NUMBER 42

BULLETIN

SUBJECT: Elevator Bungee Installation

MODELS AFFECTED: J5, Serial Nos. 1046, 1052, 1057, 1058, 1060, 1063, 1064, 1066, 1068, 1070, 1074, 1077, 1078, 1079, 1090, 1091, 1093, 1095, 1096, 1098 to 1130 and 1132 to 1137.

NEW BUNGEE INSTALLATION

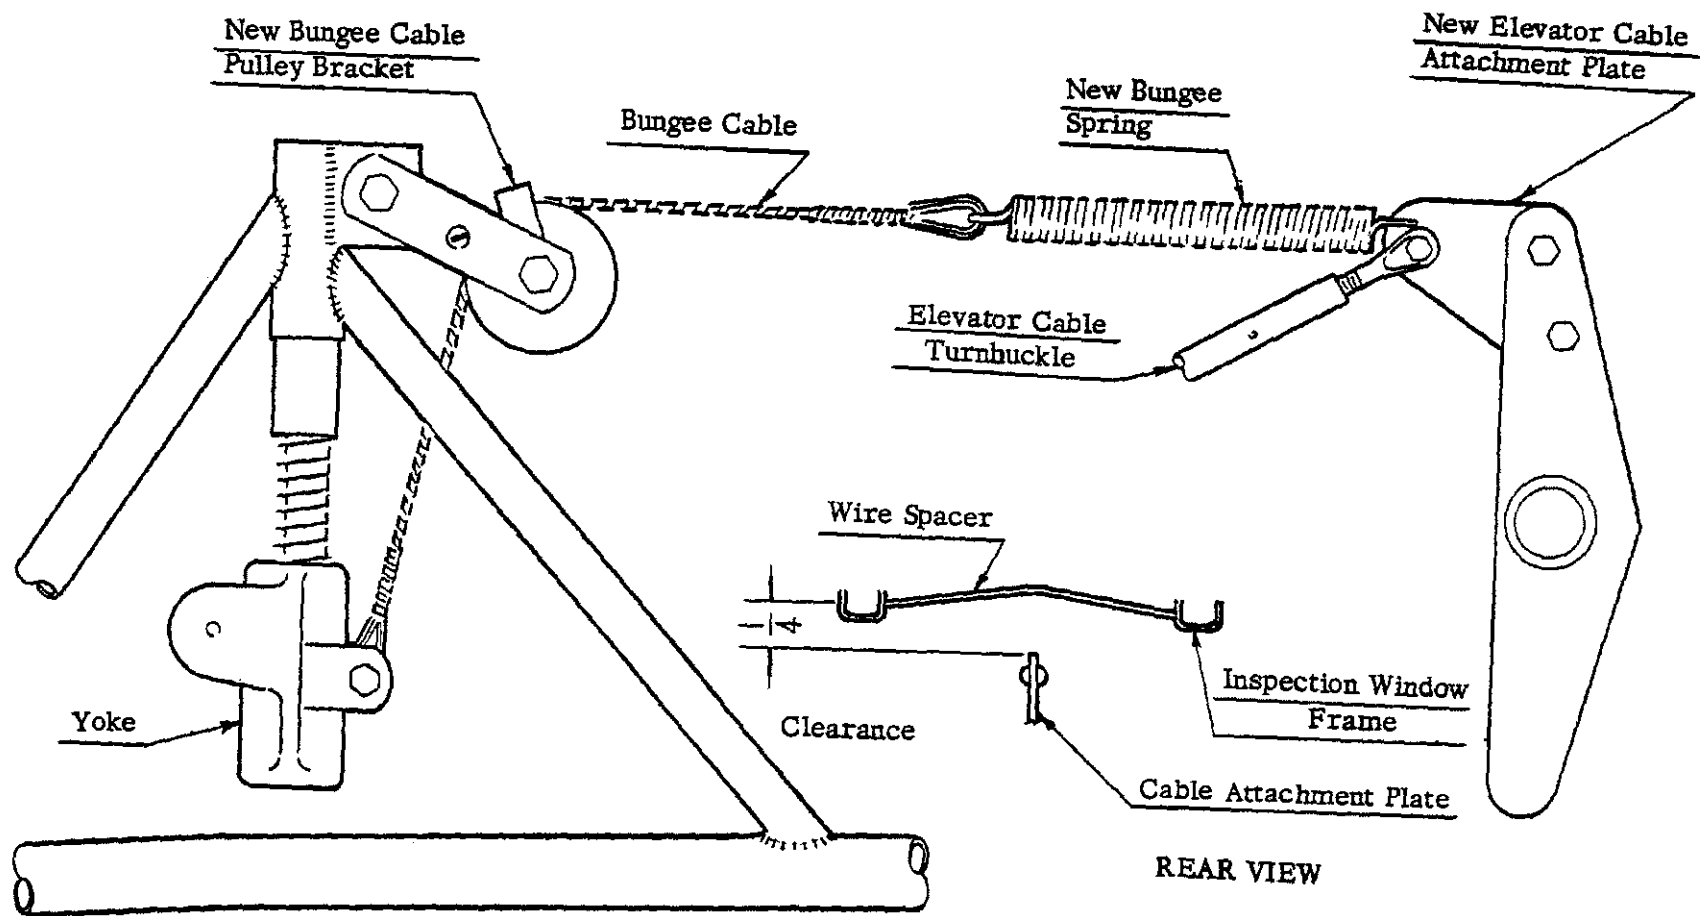
1. The Bungee cable pulley bracket, elevator cable to horn attachment plate and Bungee spring must be replaced by the parts accompanying this bulletin.

2. From the accompanying sketch it will be noted that the revised installation is similar to the original one with the exception of the above mentioned parts and the fact that the spring now attaches directly to a small hole in the elevator cable attachment plate. The small plate, washer and No. 4 screw and nut, that were used to attach the original spring, may be discarded. In dis-assembling the installation, it will not be necessary to disconnect the forward end of the Bungee cable from the stabilizer yoke and in reassembling the installation, the new spring and elevator cable link should be attached to the Bungee cable, then the new pulley bracket and pulley should be installed. The elevator cable plate should then be bolted between the elevator horns and lastly the elevator cable turnbuckle attached to this plate, making certain the turnbuckle is free to swivel.

In the fuselage structure, directly above the elevator horn, there is a wire spacer between the inspection window channels. This should be bent up in the center, if necessary, to prevent interference with the enlarged cable attachment plate. A 1/4" clearance at this point, when the elevator horn is in the most critical position, is considered satisfactory.
